ALASKA NATURAL GAS TRANSPORTATION SYSTEM

FINAL GEOTECHNIC EVALUATION

Applicant: Alaskan Arctic Gas Pipeline Company

Aerospace Report No.
ATR-76(7557)-1
Revision 1

Figure 1. Construction Equipment Noise Ranges

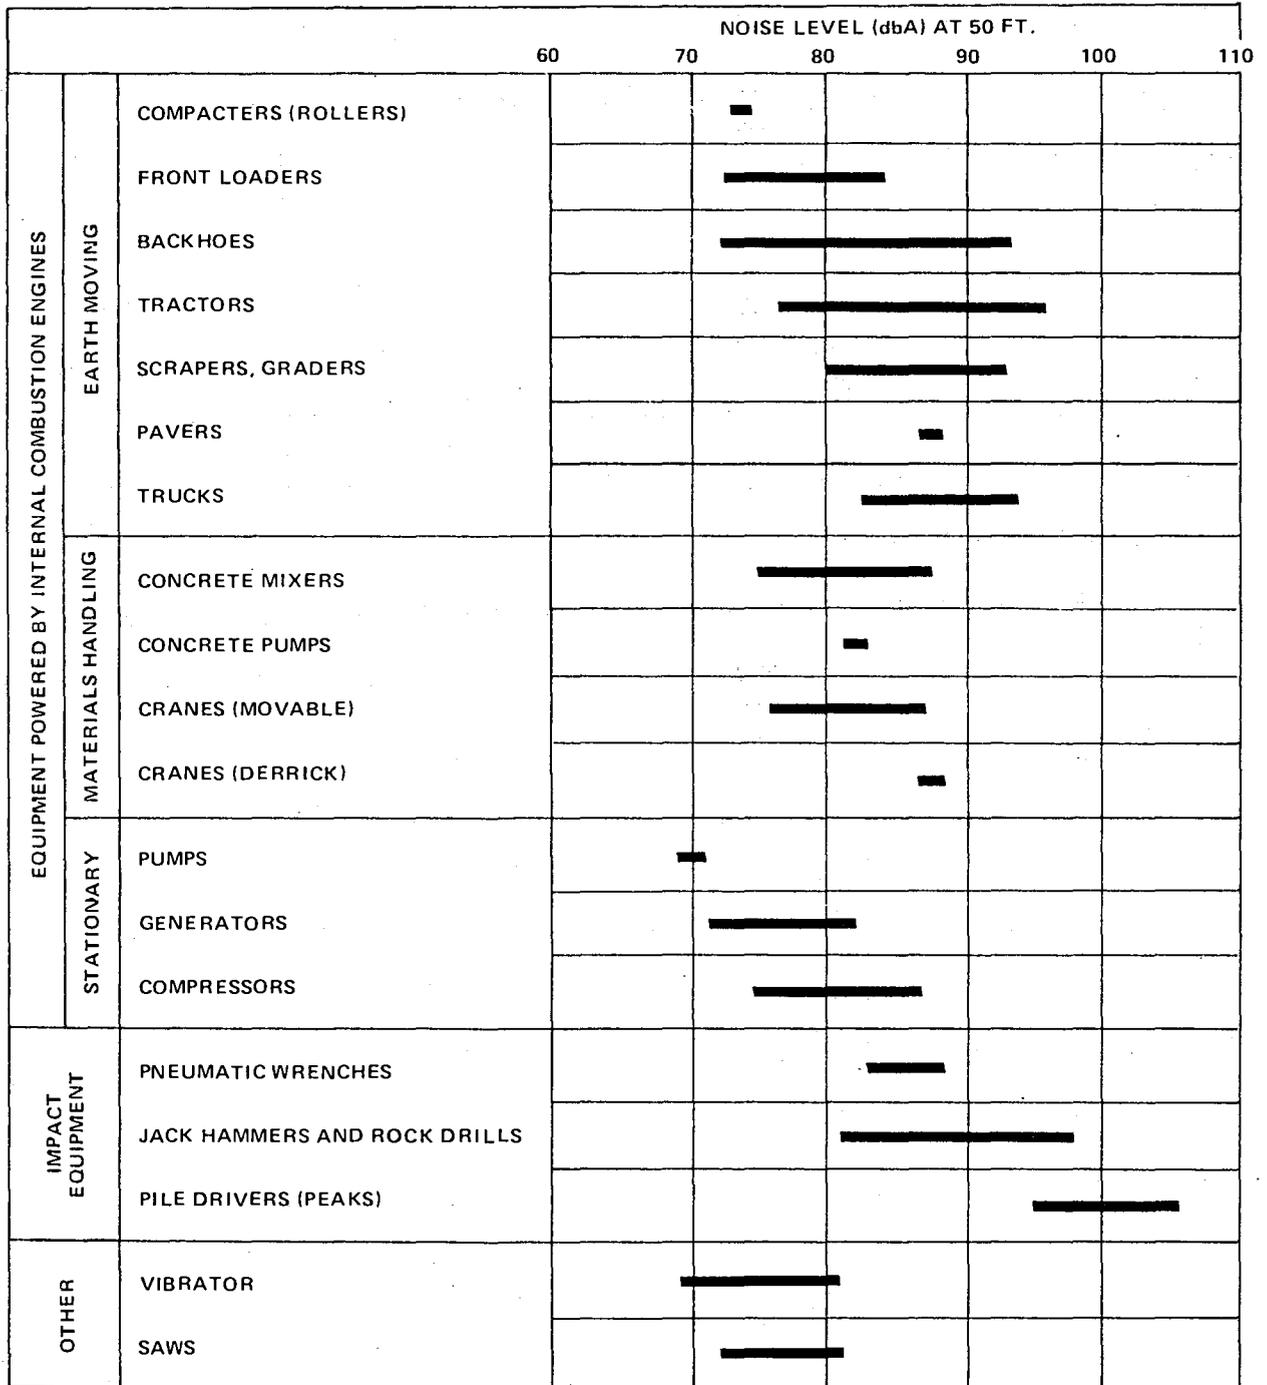
The construction noise and its effect on the environment may be underestimated by the Applicant. Figure 1 shows some typical construction equipment noise ranges. Construction would take place in an environment with very low background noise. It would involve movement of people, heavy equipment, trenching, blasting and drilling, pipe laying and backfilling.
